LAN8740 PHY DAUGHTER BOARD

Product Change Notice

This document describes a recommended change for the LAN8740 PHY Daughter Board, 04-10159, Rev. 1.0.

FIGURE 1: LAN8740 PHY DAUGHTER BOARD LAYOUT

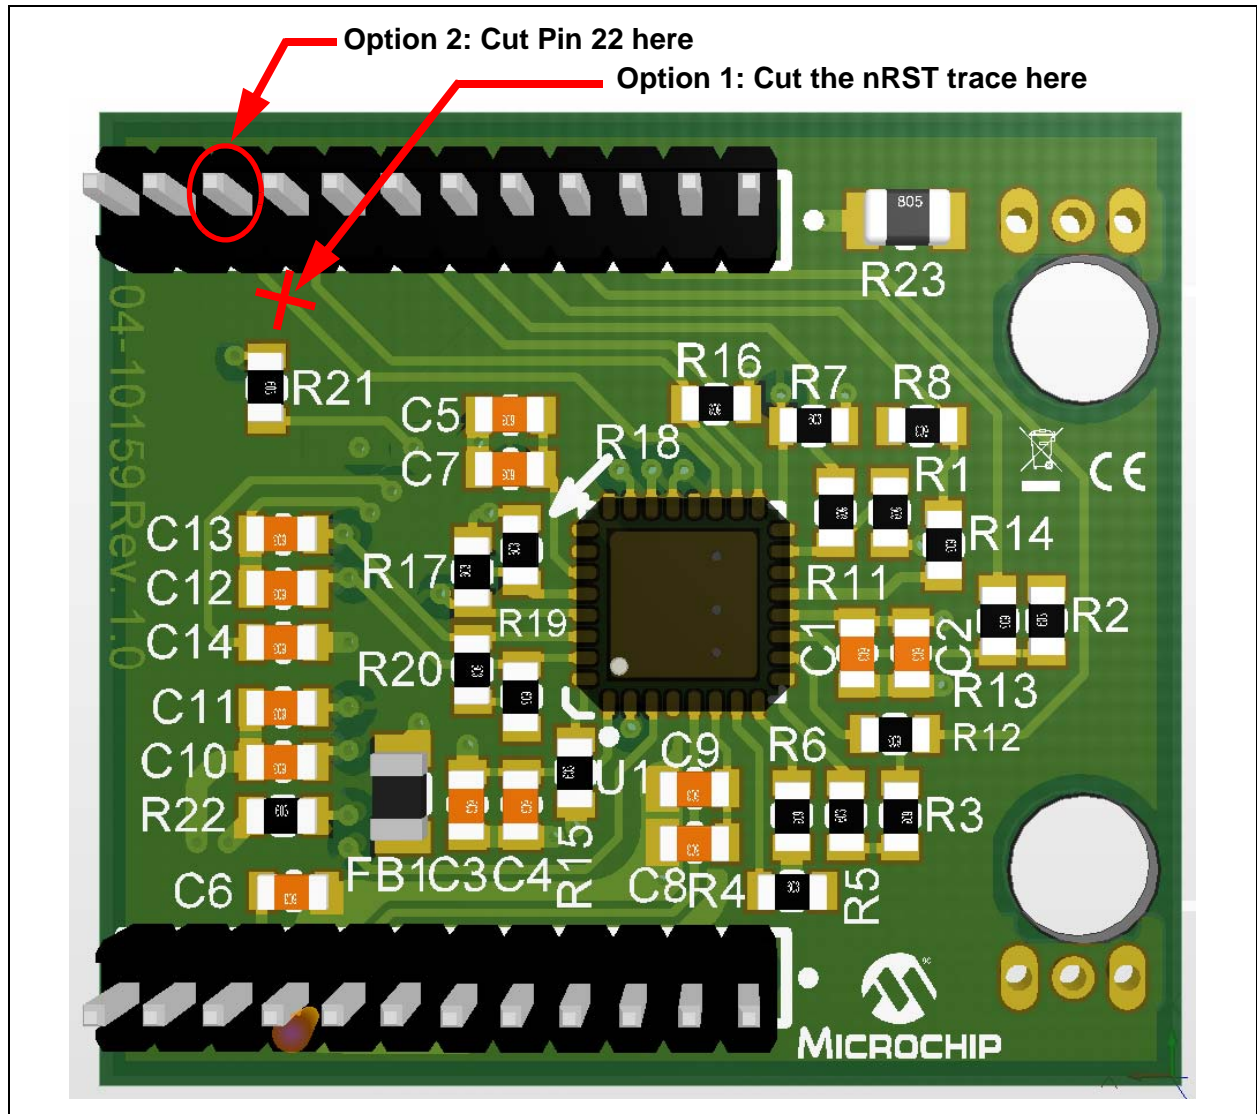
On PIC32 starter kits that utilize this PHY daughter board, the MCLR pin drives the nRST signal of the LAN8740. In some situations, the PHY may enter a latched state during programming/debugging when using either MPLAB® REAL ICE™ or the on-board

debugger. This state may occur as $\overline{\text{MCLR}}$ is driven by these debuggers with specific timing, which may differ from the specification in the LAN8740 Data Sheet.

In the event the PHY communication fails, make one of the following changes, which are shown in [Figure 1](#).

Option 1: Cut the nRST trace.

OR

Option 2: Cut pin 22.
